File:BP 79 Bramhall Street
Amdt. #1-I
(Maine Eye & Ear Infirmary)

Alterations at Maine Eye & Ear Infirmary, 79 Bramhall Street,
corner of Congress Street

BP 79 Brashall Street
(Maine Eye & Ear Infirmary)

Fire escape and other safety features at the Maine Eye & Ear Infirmary,
79 Brashall Street, to satisfy Chief's orders.

Room 74 - 5th Floor
Marie Egan and Ben Chapman

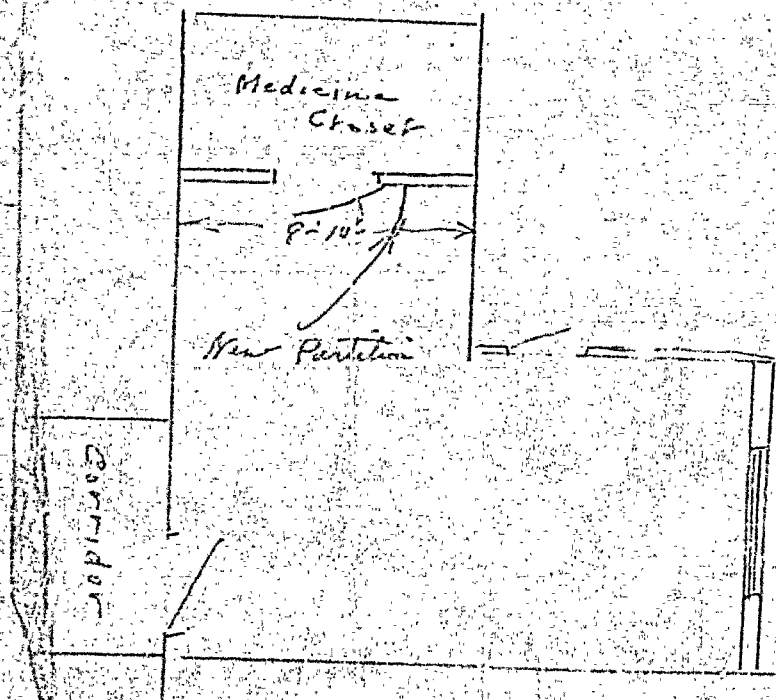
To construct non-bearing partition in Room 74 on fifth floor to provide medicine closet.
2x4, studs, 16" on centers, covered on both sides with metal and plaster.

Approved: 6/12/50 - W. L. Miller

4th floor
Main E. & C. Conference

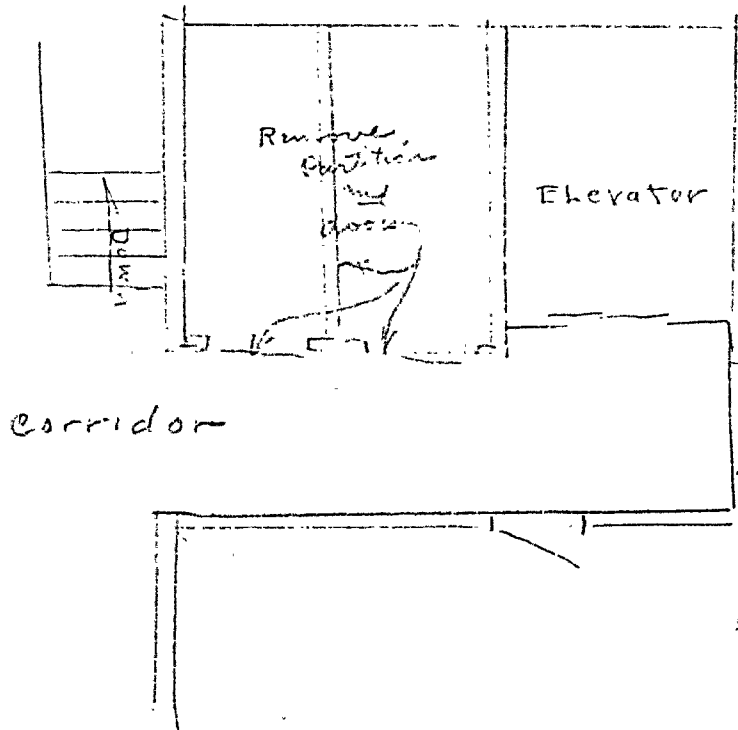
To remove non-bearing partition to provide room for chart room on fourth floor.

Approved: 2/10/50 W. L. Miller

Maine Eye & Ear Infirmary
79 Bramhall St

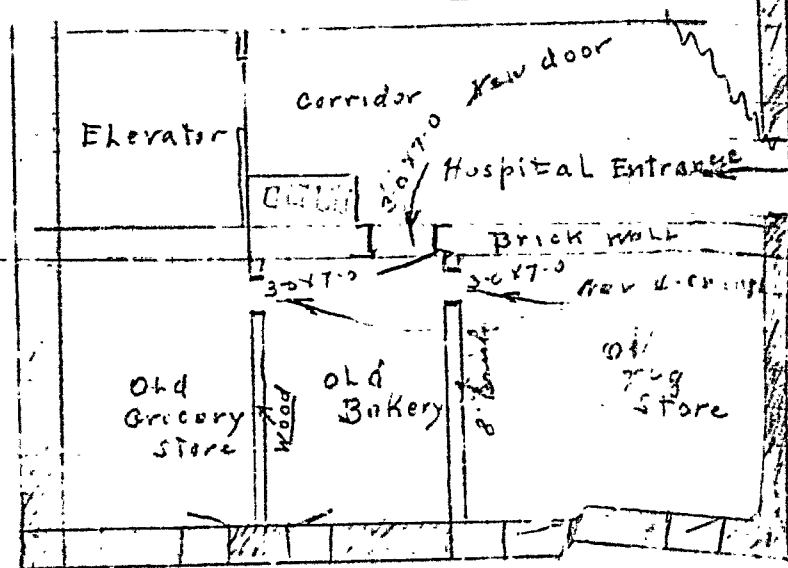
The sketch attached will explain the situation, I think. You will note that it involves cutting an opening in the brick wall between the corridor leading to the elevator from Bramhall Street to give access to the former bakery, and also to cut openings in the former bakery partitions between it and the doors on either side.

The contractor explained that no doors at all were contemplated in the wooden partition between former bakery and grocery store or in the opening in the 8-inch brick wall between former bakery and drug store. He said that the hospital authorities told him that the main purpose of cutting these openings is to store oxygen tanks in the former store spaces, but it seems obvious that once the openings are made other material or equipment will be stored in these former store spaces.

The complaint is now that if they want to get into the store spaces they have to go around onto Congress Street and go in the front doors.

Will you advise what should be done about this application--whether or not you can approve the openings at all, and if you can approve any or all of them whether or not fire doors should be provided, and if fire doors are needed whether or not they should be labelled doors in standard frames as usually required by the Building Code.

There is no particular clause of the Building Code that I can discover which would forbid cutting these openings or would call for fire doors in the openings, if so, so that the only apparent reason for denying the permit is that you would not approve it at all or would not approve it except under certain conditions because of the authority vested in you by State Law and the Safety Ordinance.

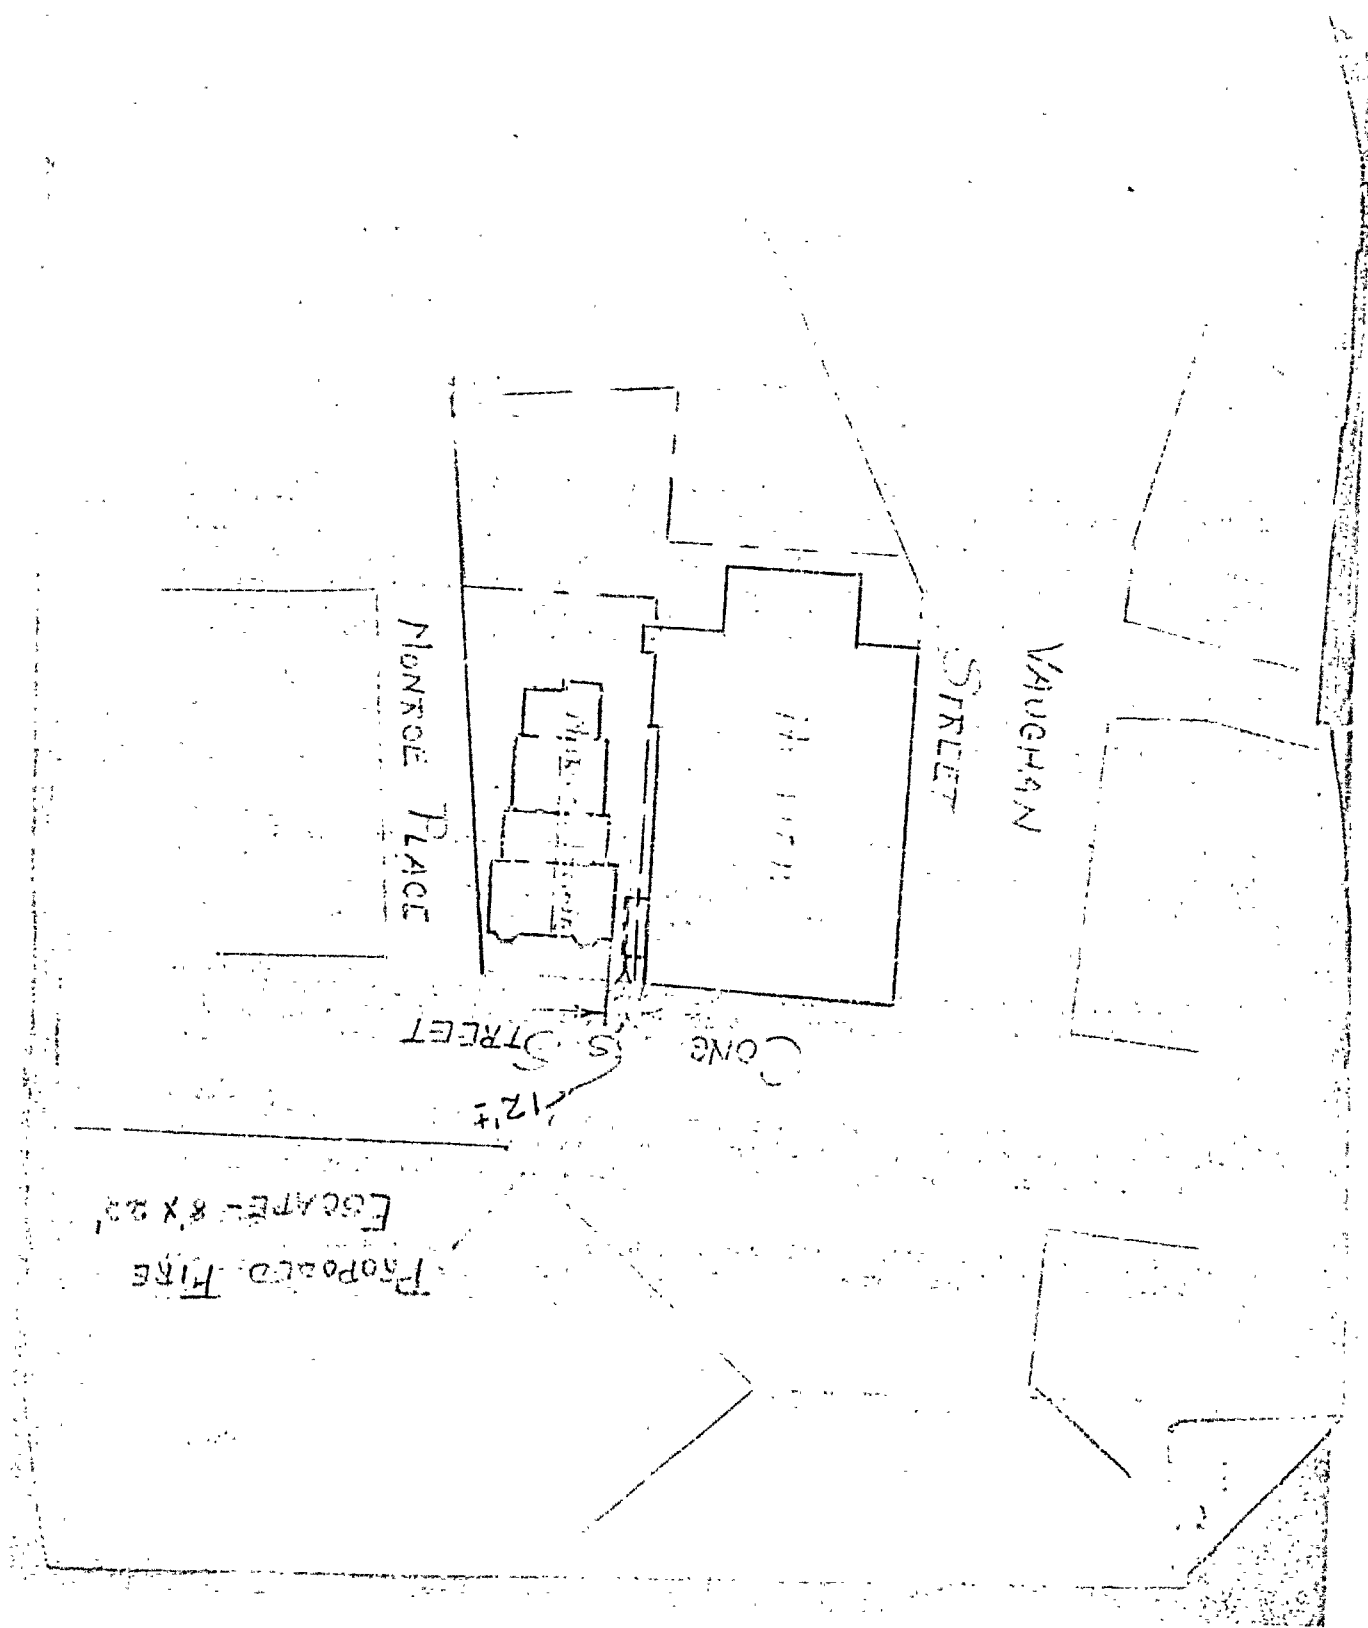
To cut in door in brick wall between hall and former bakery in first floor.
To cut in door in 8" brick wall between former pharmacy and bakery, first floor.
To cut in door in wood partition between former bakery and grocery store, first floor.

Permit to the Dept. 1/16/50
Rec'd from Fire Dept. 1/19/50
